**ADDENDUM NUMBER 2
FOR
SCAPPOOSE BAY MARINE PARK
MARINA IMPROVEMENTS PROJECT PHASE 1**

This addendum forms a part of the Contract Documents and modifies the original Bidding Documents dated **July 12, 2024** and any previously issued addenda as noted below. Acknowledge receipt of this Addendum in the space provided on the Bid Form. Failure to do so may subject the Bidder to disqualification.

SCAPPOOSE BAY MARINE PARK
MARINA IMPROVEMENTS PROJECT UPLAND PHASE 1

DEMOLITION PLAN - UPLAND SOUTH

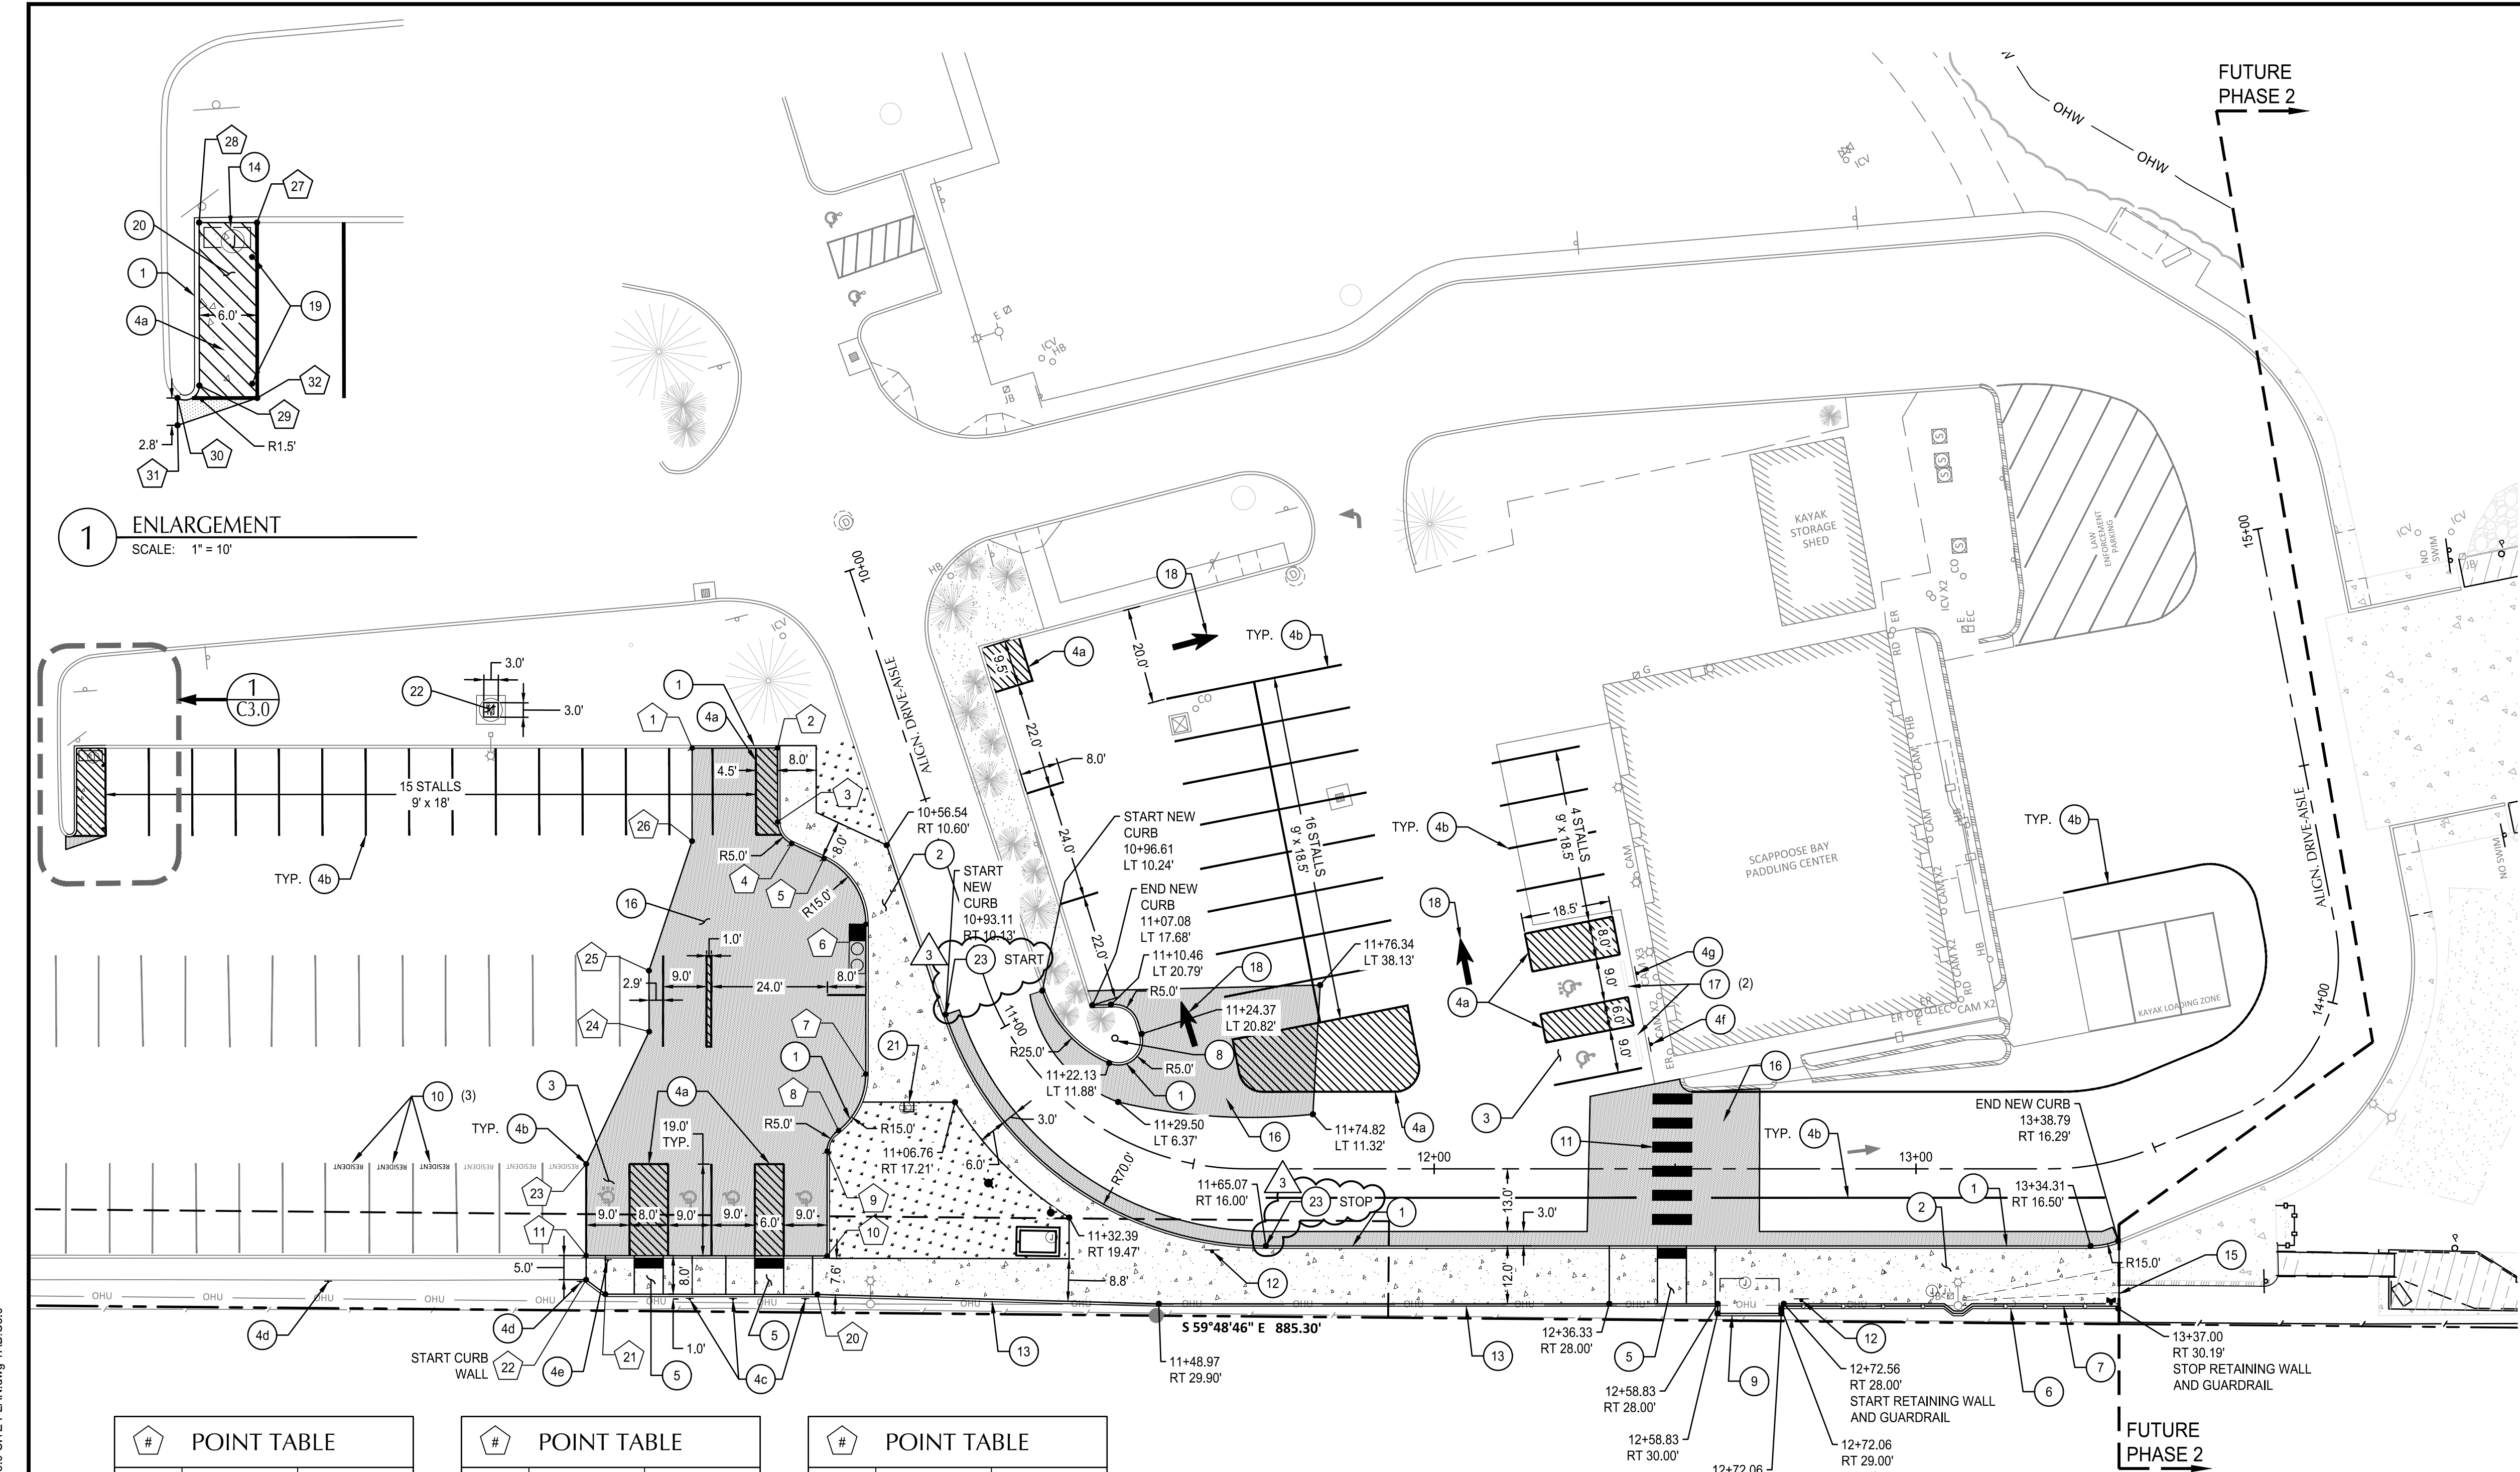
- Reissue sheet C1.0 – Demolition Plan – Upland South in its entirety with revisions clouded.
- Reissue sheet C3.0 – Upland Site Plan in its entirety with revisions clouded.
- Reissue sheet C3.1 – Upland Site Plan in its entirety with revisions clouded.
- Reissue sheet C5.0 – Upland Utility Plan in its entirety with revisions clouded.
- Reissue sheet C8.1 – Details in its entirety with revisions clouded.
- Reissue sheet S5.1 – Typical Concrete Details 2 in its entirety with revisions clouded.
